## DEVELOPMENT REVIEW COMMITTEE (DRC) COMMENT REPORT

**PROJECT NAME:** 401 NE 4th

**CASE NUMBER:** R19057

**REQUEST:** Site Plan Level II Review: 4,111 Square Foot  
Retail Building in Downtown Regional Activity  
Center

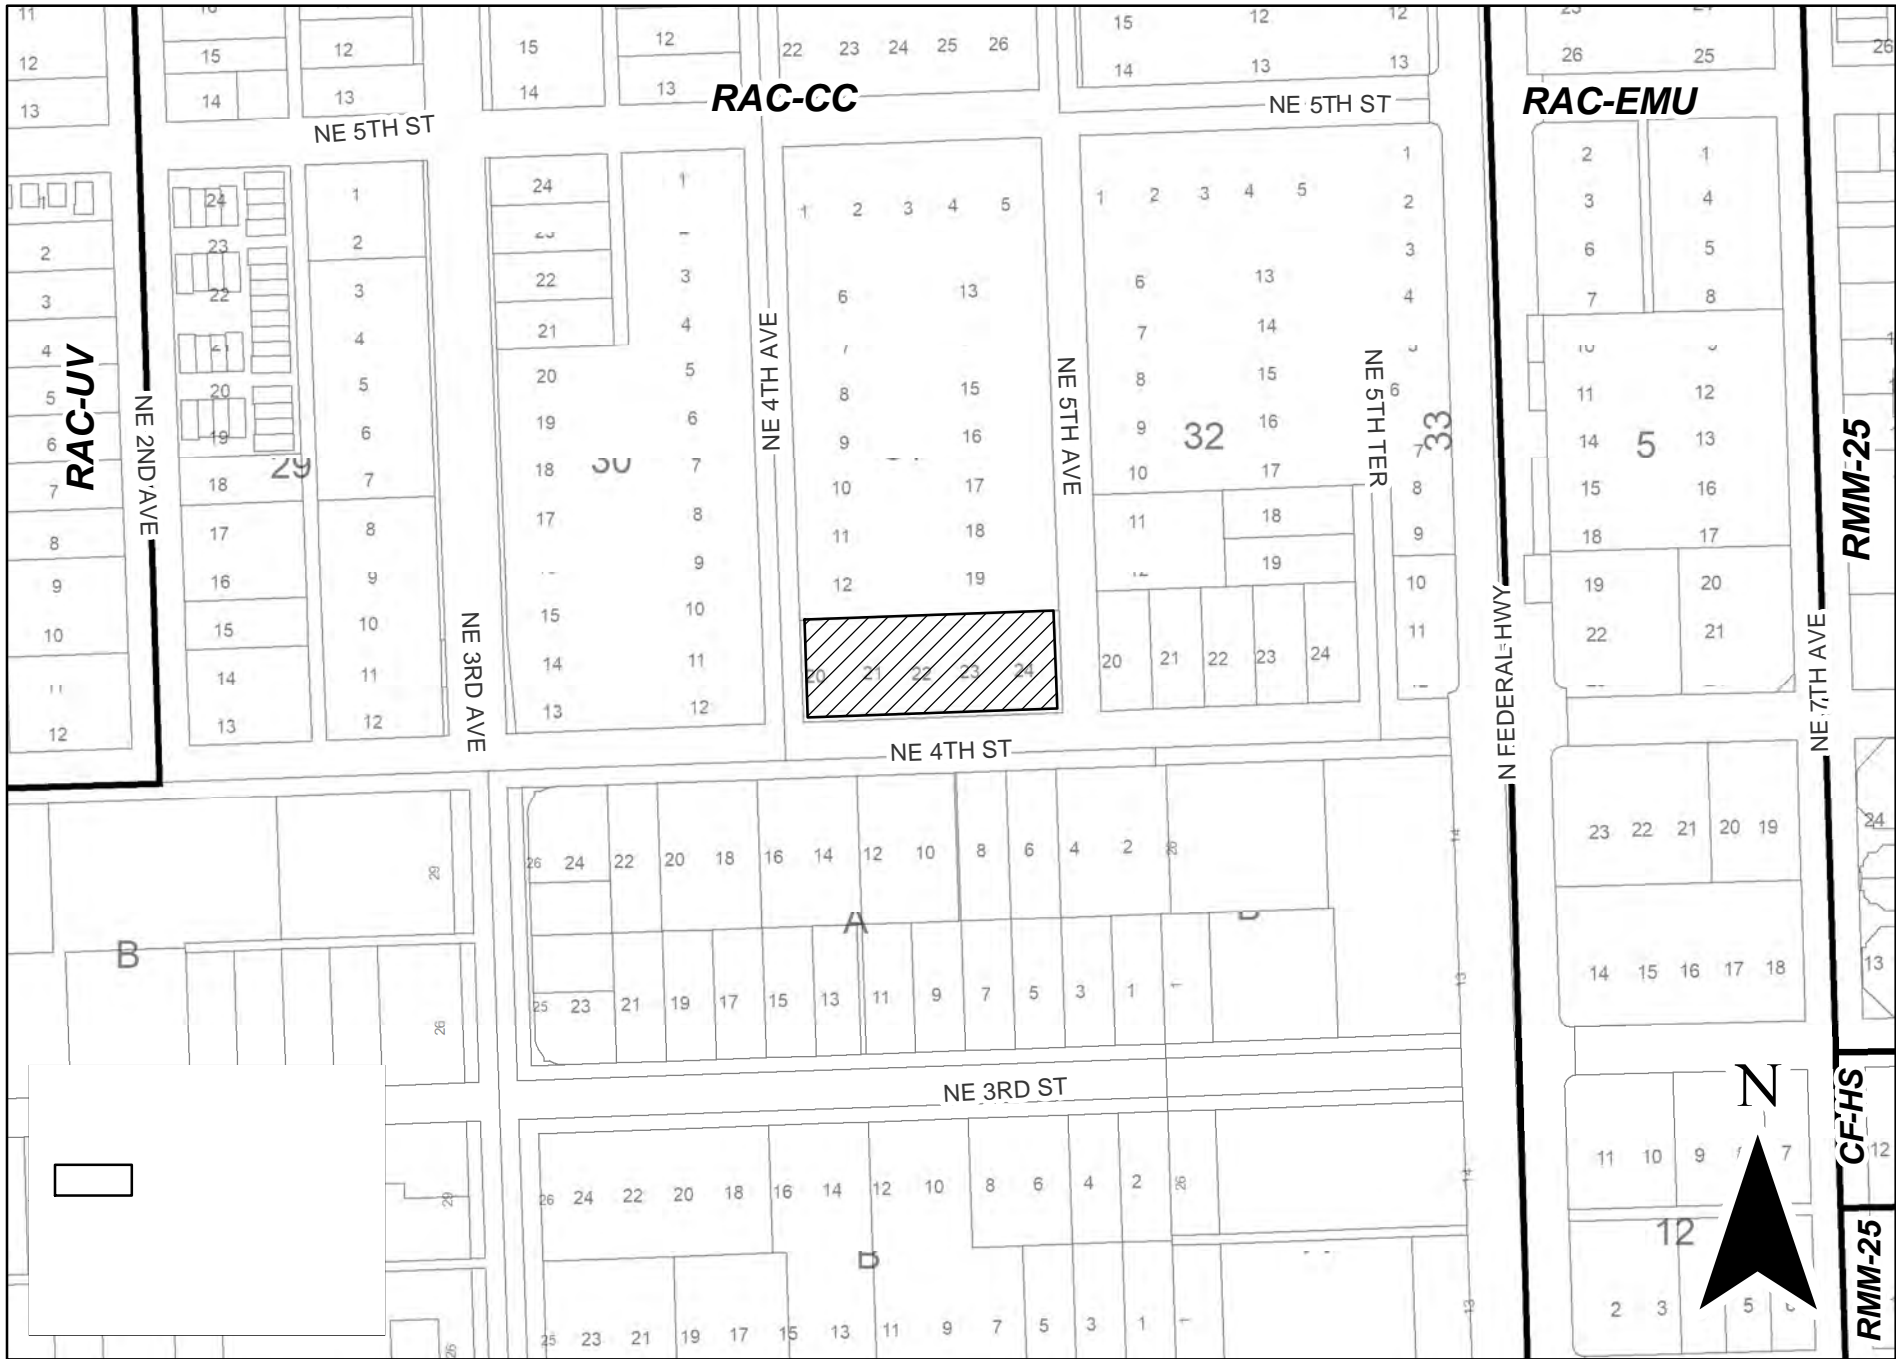
QUALITY OF ARCHITECTURE		Meets Intent	Doesn't Meet Intent	N/A	More Information Needed
Q1	Skyline Drama: Encourage towers to contribute to the overall skyline composition.			√	
Q2	Expressive Tops: Encourage expressive tops for tall buildings above 37 stories in Near Downtown and Downtown Core.			√	
Q3	Durability and Quality of Materials: Encourage high quality materials for the entire building, with special emphasis on detailing and durability for the first 2 floors. <i>Provide elevation details indicating cladding materials.</i>		√		
Q4	Respect for Historic Buildings.			√	
Q5	Parking Podium Façades: Where structured parking must be exposed to the street, exceptionally creative solutions should be explored.			√	
Q6	Response to Natural Environment: Encourage architecture to respond to the unique nature of the south Florida environment (solar orientation, wind direction, rain). Examples: Open breezeway corridors oriented toward prevailing winds; energy efficient glazing; above ground stormwater capture and re-use through bio-swales and rain gardens; solar roof panes/awnings. <i>Provide building sustainability narrative.</i>				√

Q7	Creative Façade Composition: Encourage a rich layering of architectural elements throughout the building, with special attention to facades below the shoulder level.	√			
Q8	Original, Self-Confident Design: Encourage a range of architectural styles that each create a strong identity, strive for the highest quality expression of its chosen architectural vocabulary.				√
